To: Brian Trulear/R3/USEPA/US@EPA
cc: "Ferry, Martin" <mferry@state.pa.us>
bcc:
Subject: FW: Comments--Proposed NPDES Permit

October 30, 2006

Re: Draft NPDES Permit No. 0008869
P. H. Glatfelter Company Comments

Table 1**Table 1: AOX in Secondary Effluent**

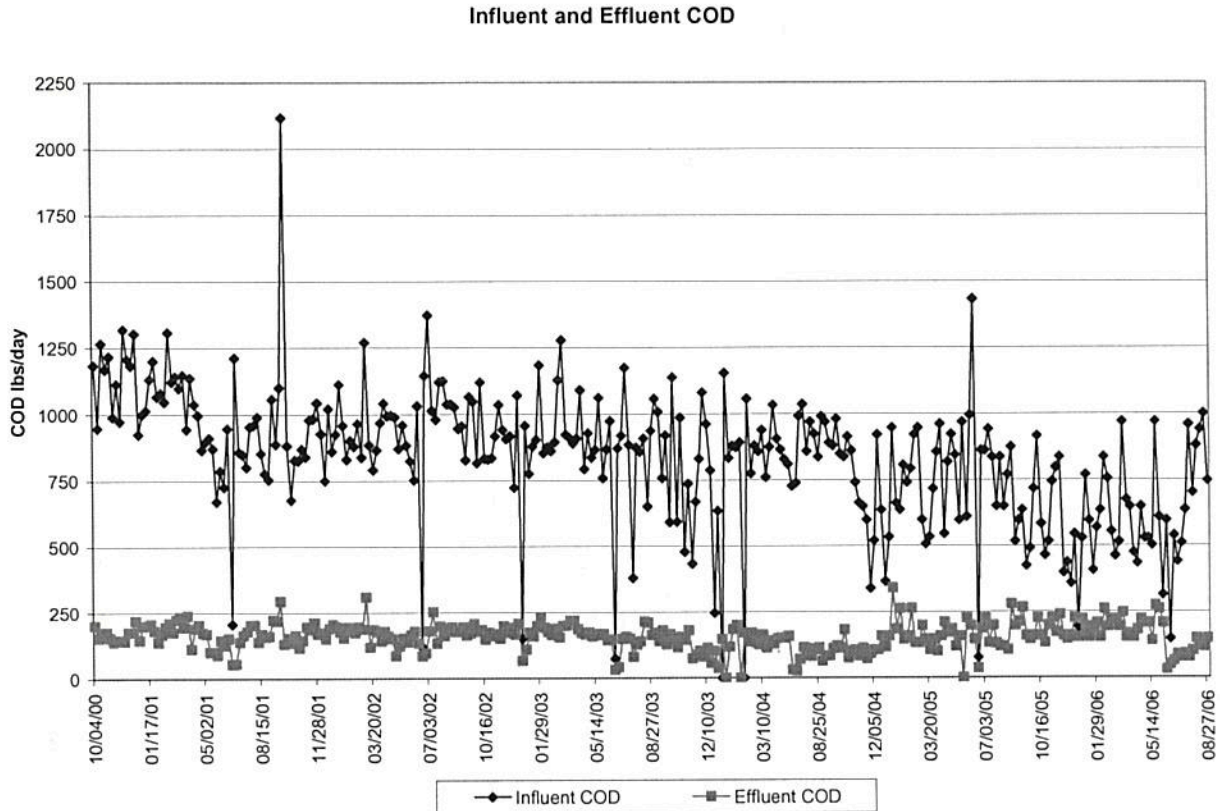
- b. The once monthly minimum monitoring requirement for AOX should be reduced to a frequency of once quarterly in November 2008. 40 CFR 430.02(e) states that the once monthly minimum monitoring frequency is applicable to Advanced ECF dischargers in the VATIP for a duration of four years starting one year after achievement of the applicable BAT limitations set forth in 40 CFR 430.24(b)(4)(i). Glatfelter has been in compliance with the applicable BAT limitations since November of 2003 and certified that it meets the advanced ECF criteria. Pursuant to 40 CFR 430.02, the appropriate monitoring frequency for effluent AOX after 5 years of compliance with the BAT limitations should be determined by DEP in accordance with 40 CFR 122.44(i).

Glatfelter is currently monitoring AOX on a daily basis. The data collected since the effective date of Glatfelter's current permit is shown in Table 1. Based on the consistency of AOX discharge levels since the implementation of ECF bleaching in late 2003 and the large compliance margin, Glatfelter believes that once quarterly monitoring for AOX would be wholly adequate to demonstrate compliance with the AOX discharge limitations.

Table 4

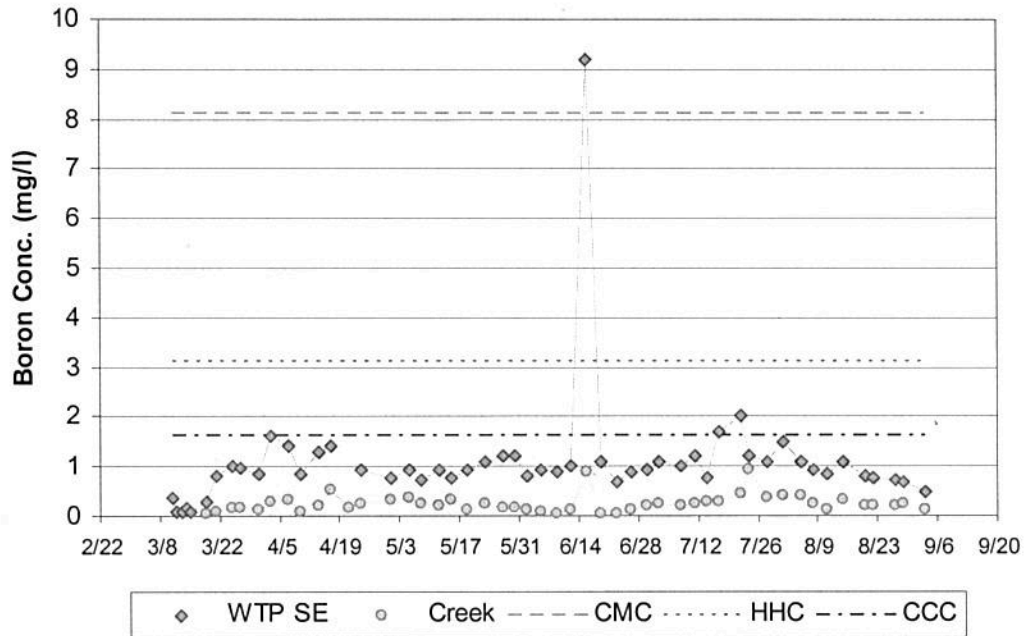
9. *Requirements Applicable to Autocausticizing; Footnote 12, Page 10.* Glatfelter began using the autocausticizing process at a limited rate on August 7, 2006. Glatfelter received a Plan Approval from the Bureau of Air Quality on 5/26/2006 for use of the process at a rate not to exceed 4% autocausticizing. The previous autocausticizing trial was run at an average autocausticizing rate of 12.5%. The boron data collected for Glatfelter's effluent during the last trial showed that the concentration of boron in the Codorus Creek was significantly less than the water quality criteria for boron at all times. The boron data from the trial is shown below in Tables 4 and 5.

The 6/16/03 spike in the boron concentration in our secondary effluent concentration was caused by the sewerage of Pulpmill liquors for the annual Mill maintenance shutdown. Despite the increase in effluent concentration, the Creek concentration remained well below the water quality criteria, as the CMC criteria applies to the stream concentration, not the discharge. Based on the boron data from the previous trial and the fact that autocausticizing is currently operating at less than one third of the rate of the previous trial, Glatfelter requests that the Department impose a monthly boron monitoring requirement for the secondary effluent rather than weekly monitoring for both the effluent and the Codorus Creek. Glatfelter would also monitor for boron whenever there is an exceedence of the BMP action levels developed and implemented pursuant to 40 CFR 430.03 (indicating that liquor from the Pulpmill was sewerage). We do not believe that instream monitoring for boron is
